Re: Hudson Bay Mining and Smelting Co., Limited – Reed Mine *Environment Act* Proposal
Your File Number: 5621.00
TAC Response Submission

Thank you for forwarding the comments provided by your Technical Advisory Committee (TAC) concerning our *Environment Act* Proposal for Reed Mine. The following further information is submitted in response to the TAC comments. We have reviewed each of the TAC submissions and attempted to consolidate the comments by subject area. Where like comments have been submitted by two or more reviewers, we have consolidated them and address them as one response.

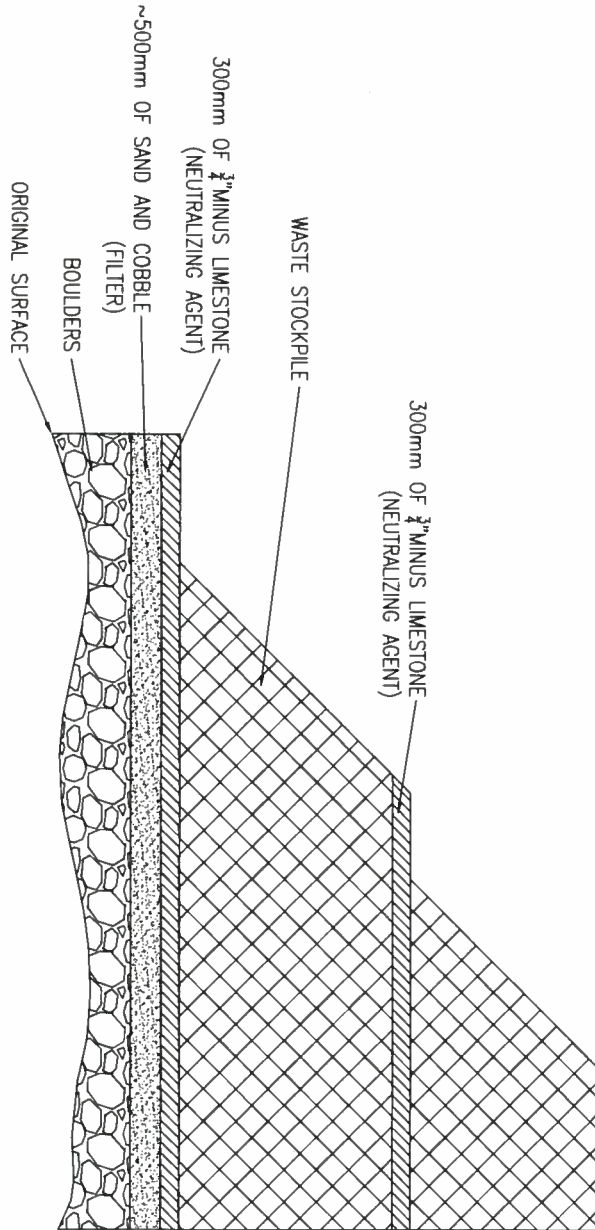
How will runoff from storage pads of waste rock and ore be managed? For example, will it be directed to the polishing pond?

As noted above, the waste rock storage pad has been constructed and is in operation. Our operational experience with this storage pad and others in the region (Flin Flon and Snow Lake) is that little drainage occurs off the rock piles. Snow melt occurs quickly and runs off the outside of the pile as opposed to permeating through the pile. Rainfall is generally absorbed or will quickly evaporate, and very little, if any, will permeate through the rock piles.

Any such runoff is collected in a perimeter ditch, where it is reabsorbed into the surrounding soil. Although the waste rock storage pad will be used to store rock that is expected to be primarily non-acid generating, some material placed on the pad as the project progresses toward mining has the potential to be acid generating. As stated above, to mitigate the effects of acid rock drainage, any water that permeates into the pad will pass through layers composed of limestone boulders, sand and cobble, and crushed limestone which will filter and neutralize any potentially

acidic runoff generated by the stockpile. This neutralized runoff will then be absorbed by the soil and wetlands surrounding the waste rock storage pad.

To further facilitate acid neutralization, the waste rock will be placed on the stockpile in lifts (layers), with each lift 3 to 4 m high with a layer of crushed limestone and sand between two lifts. Very little runoff is expected to flow through the rock piles as the fine material in the layers will absorb moisture.

Ore Storage Pad

Runoff from the ore storage pad will be collected in a surface sump (see Figure 8 in the EAP), and pumped to one of the underground sumps which collects seepage and process water. From there, it will be discharged to the polishing pond. Water quality in the polishing pond is measured weekly and treated, when required, to meet the applicable Tier 1 criteria set out in Manitoba Water Quality Standards, Objectives and Guideline.

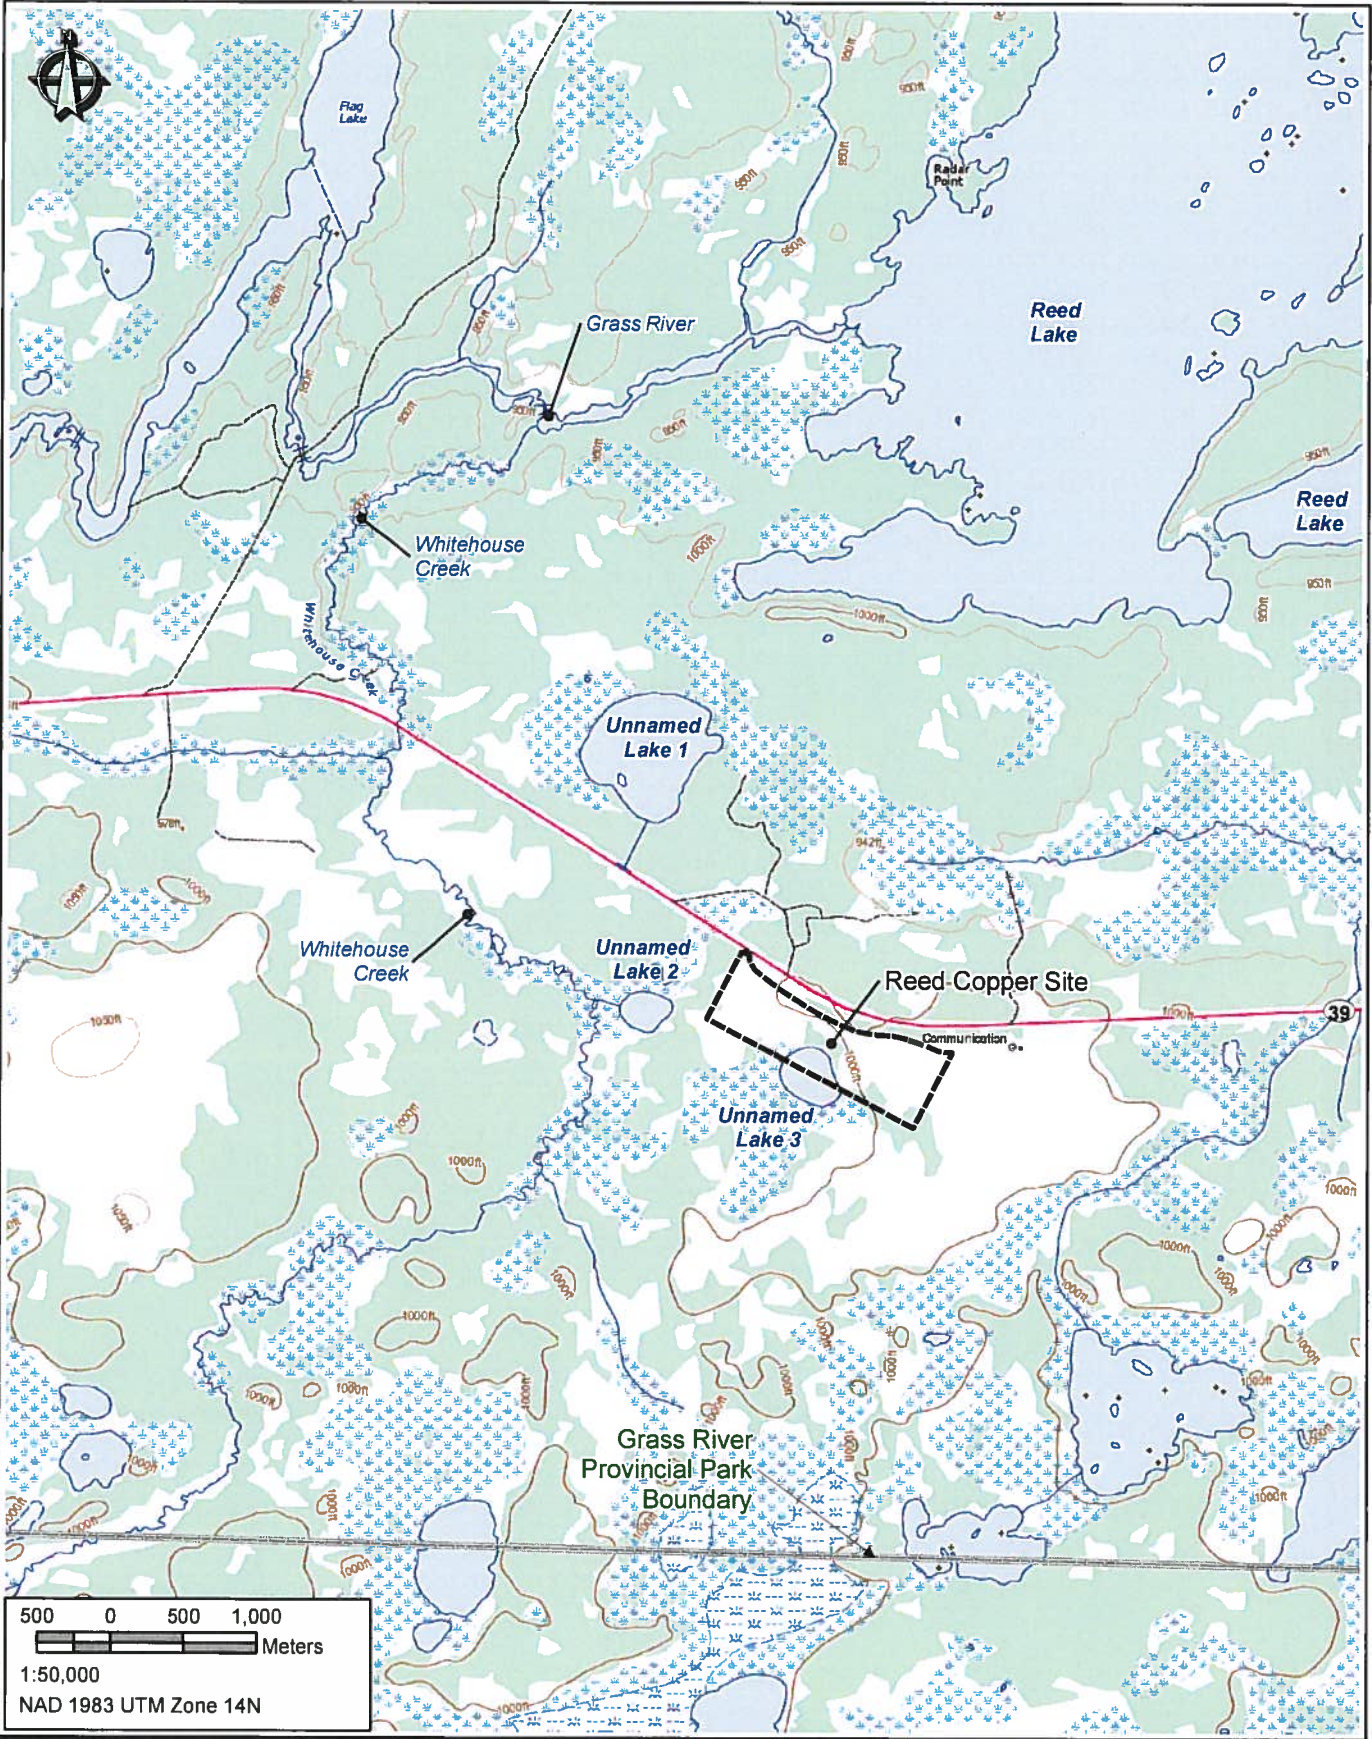
Additional water quality monitoring of Lake 3, [Whitehouse] Creek and Un-named [Lake] 2 is recommended.

HBMS agrees to the development and implementation of a water quality monitoring program at locations downstream of the polishing pond discharge point. We attach for your review the proposed *Reed Mine Downstream Effects Monitoring Matrix*, which details the proposed water quality monitoring program for Unnamed Lake 3, a creek/wetland monitoring location, and Whitehouse Creek. Although quarterly sampling is normally preferred, due to conditions of the proposed sampling locations during winter months (water depth, accessibility) we propose sampling at these locations three times per year (spring, summer, and fall).
